# UP AND DOWN AND ALL AROUND

## An upgrade to Nailor DH Series Electric Duct Heaters and Model 30RE Single Duct Terminal Units.

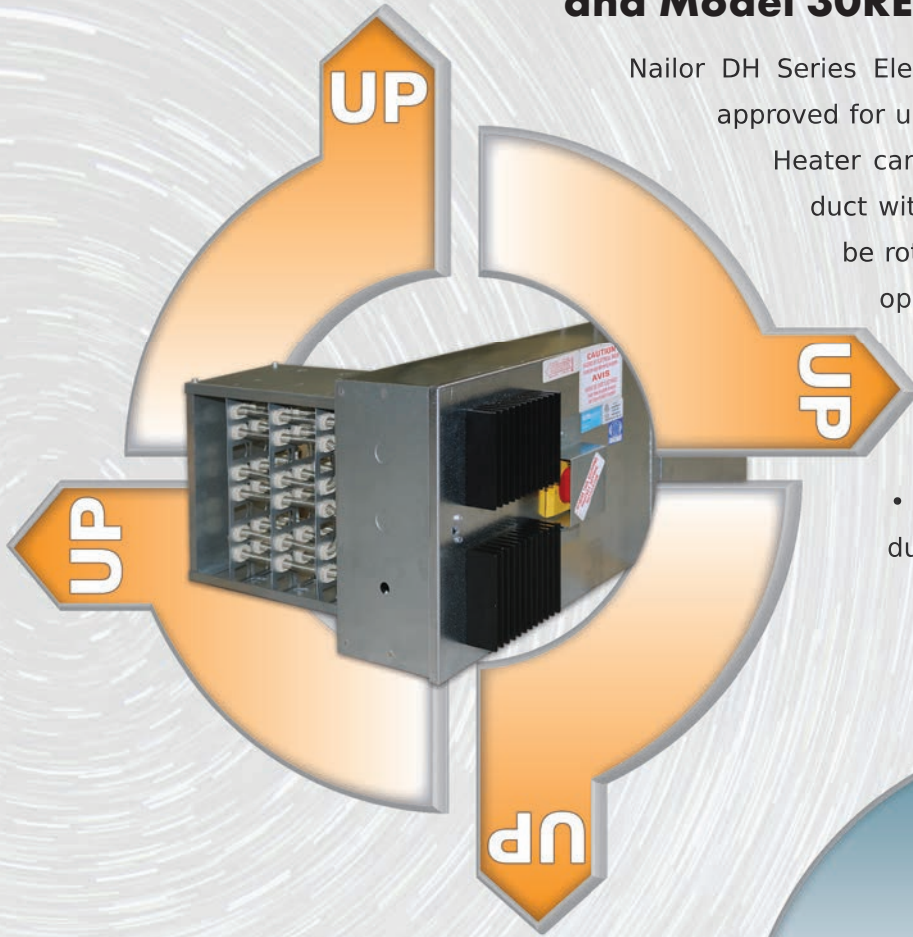
Nailor DH Series Electric Duct Heaters are now designed and approved for universal installation. The same Electric Duct Heater can be applied in both horizontal and vertical duct with airflow in either direction. They may also be rotated to place the controls enclosure on the opposite side where field restrictions dictate.

- Changing airflow direction in the field (from factory order) requires nothing more than rotating the airflow switch pick-up probe.
- Changing from a horizontal duct to a vertical duct requires the SCR (if there is one) to be rotated 90 degrees. The heat sink fins must be in a vertical orientation.

Nailor Model 30RE Single Duct Terminal Unit with Electric Reheat can still be flipped over for Right Hand or Left Hand control enclosure orientation, but now they can now also be applied for both horizontal and vertical installation.

- The same rule as above apply for SCR controls.

Ordering procedures still require a desired airflow direction and orientation so that the labels, probe tube and SCR can be properly positioned for the application. However, if the application changes, you no longer need to purchase a new heater or terminal unit. Field changes to the heater are simple.
